FLORIDA POWER & LIGHT COMPANY
June 23, 1977
L-77-191

Re: Turkey Point Units 3 & 4
Docket Nos. 50-250 and 50-251
Proposed Amendment to Facility
Operating Licenses DPR-31 and DPR-41

Figure 2.1-1

Fig. 2.1-1. Reactor Core Thermal and Hydraulic Safety Limits, Three Loop Operation

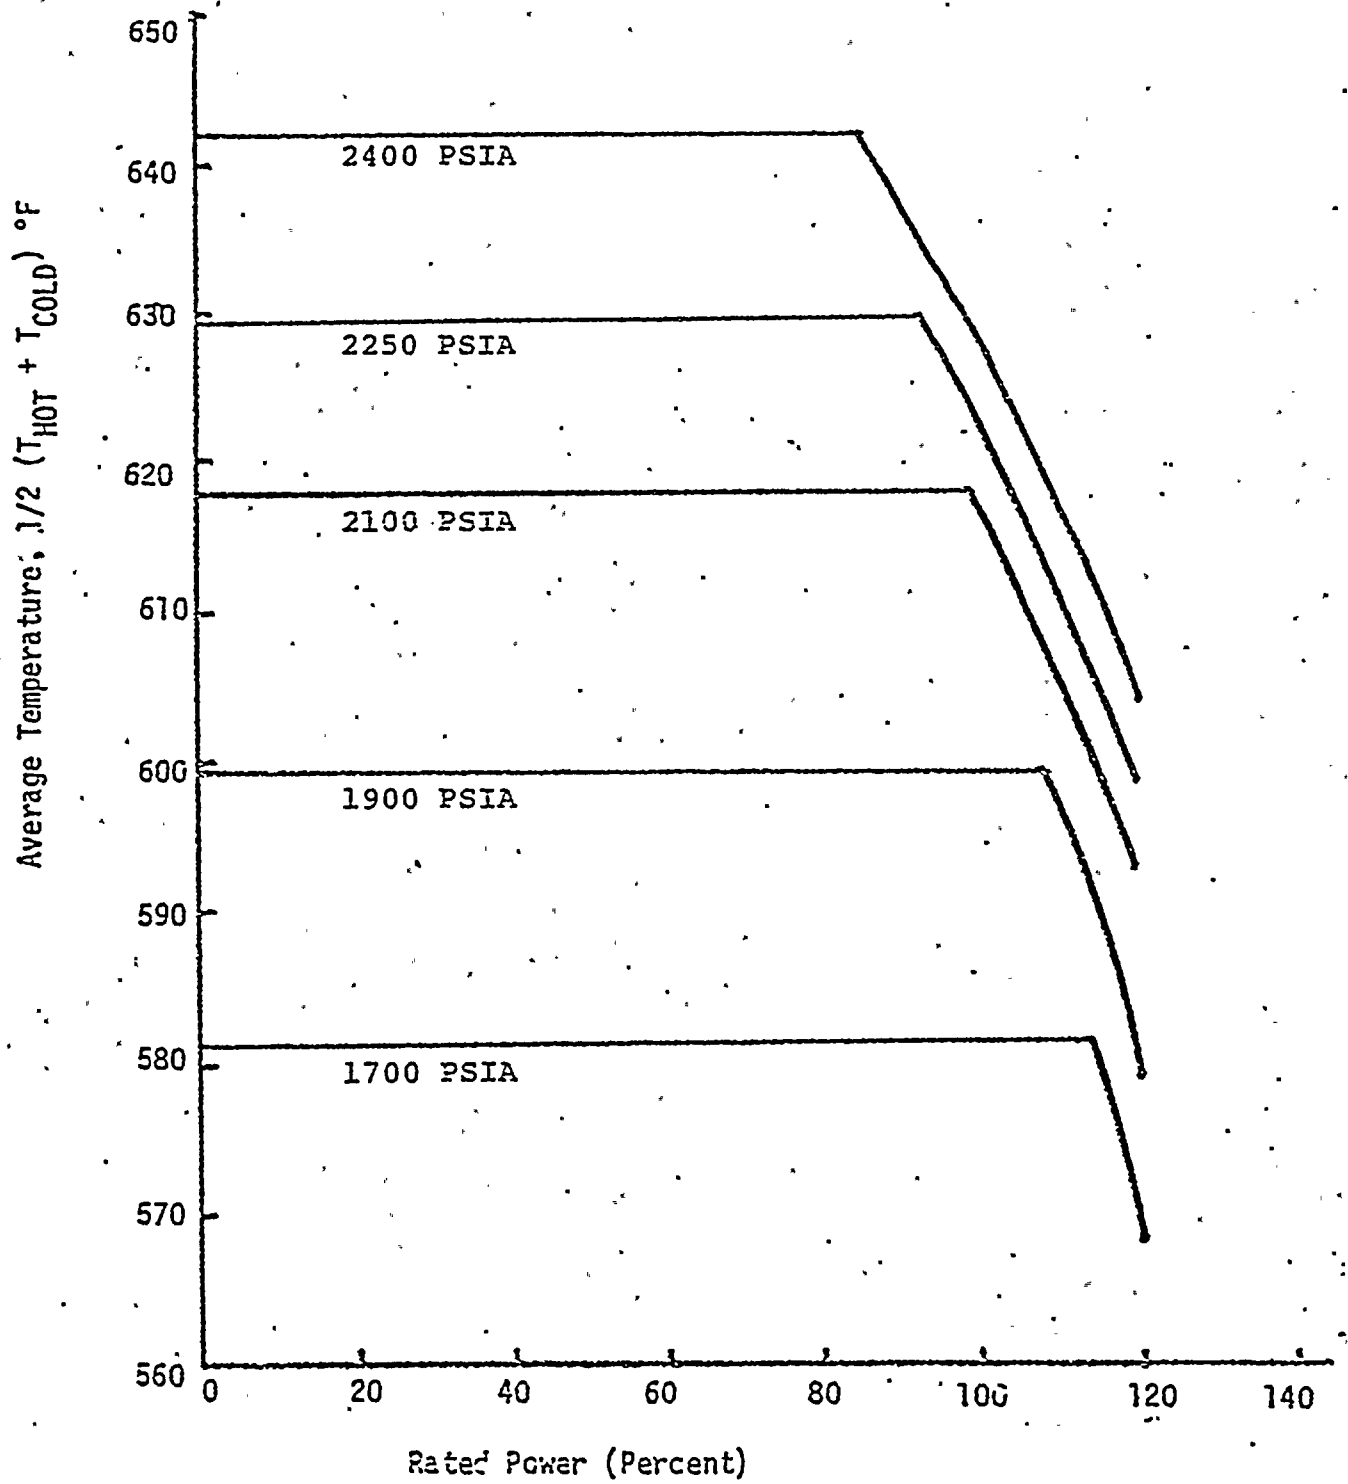
An analysis performed by our NSSS vendor has resulted in a corrected Figure 2.1-1 applicable at the licensed steady state reactor core thermal power output of 2200 Mwt.

012 Discussions with our NSSS vendor have shown that Technical Specification Figure 2.1-1, "Reactor Core Thermal and Hydraulic Safety Limits", requires revision. An analysis performed at 2200 Mwt has yielded a corrected Figure 2.1-1 applicable to both Units 3 and 4. No changes to setpoints, operating limits, or operating practices are required as a result of this correction. Neither unit has ever operated nonconservatively as a

This occurrence was caused by a difference between the values of "nominal power" applied to Turkey Point Units 3 and 4 by FPL and the NSSS vendor. The vendor performs analyses based on a nominal power of 2200 Mwt, our licensed steady state reactor core thermal

power output. However, they recently advised us that the specific number being used for analytical work was 2192 Mwt. An analysis performed at 2200 Mwt showed that, in a single case, it would be necessary to make a minor administrative change to a Technical Specification (Figure 2.1-1). Figure 2.1-1 has been adjusted downward the necessary amount (approximately 1.5°F) to compensate for the correction. A proposed Technical Specification amendment will be submitted to the NRC to request a formal change correcting Figure 2.1-1.
